# Anglia Square, Norwich Environmental Noise Assessment

## Addendum

# **ENVIRONMENTAL NOISE ASSESSMENT ADDENDUM FOR ANGLIA SQUARE, NORWICH**

## **Environmental Noise Assessment Addendum: Comments on Norwich City Council Environmental Protection Team Response on ENA (NCC Ref: 18/00330/F)**

Pitt Street elevation

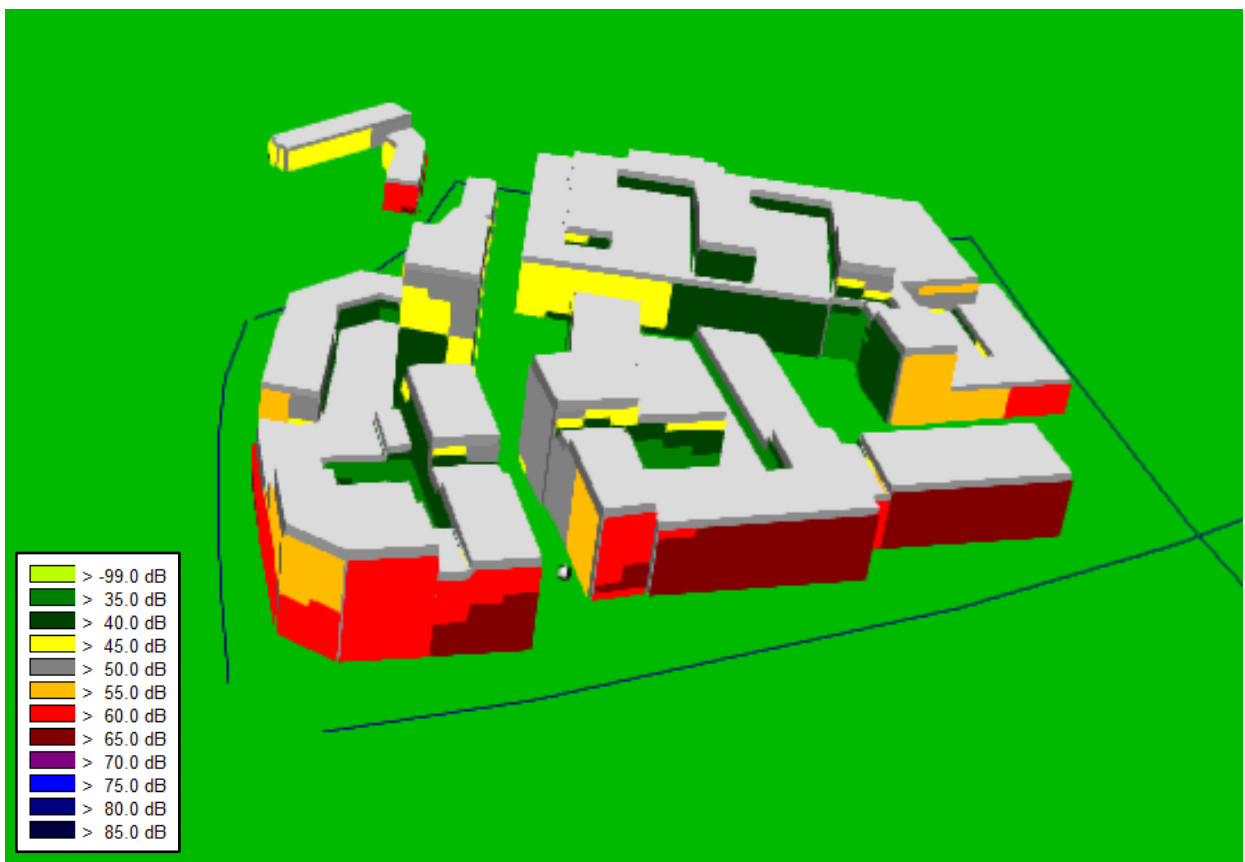
- The number and position of balconies that will be subject to road traffic noise in excess of 55dB has not yet been determined, (the Stansted Environmental Services Ltd assessment has not calculated noise levels at the facades or balconies but has taken monitoring levels from individual measurement positions). Further data manipulation will be required and it may also be appropriate to regard St Crispin's Way (Road?) as a line source.***

Please refer to the various CadnaA screen shots at the end of this Addendum note. Whilst some facades are not expected to achieve the targeted 55dB LAeq for external amenity space for the

daytime, avoiding such facades for balcony placement should be carefully considered. For example, St Crispins Rd shows a calculated dB level 65dB at the façade. Areas within the development will benefit from shielding produced by the building themselves. This is shown the Pitt Street elevation with areas of 45dB (yellow) and less.

St Crispins Road elevation

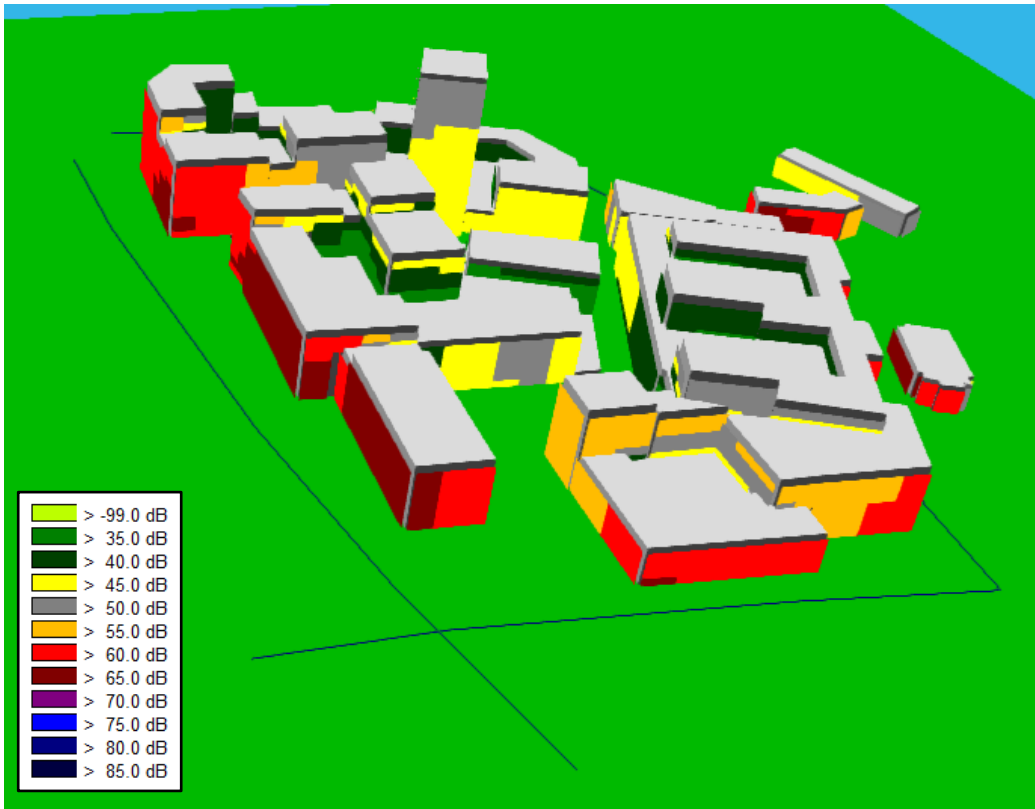
***Concern proximity of block J to St Crispins flyover will result in unacceptable noise levels for dwellings facing the flyover***
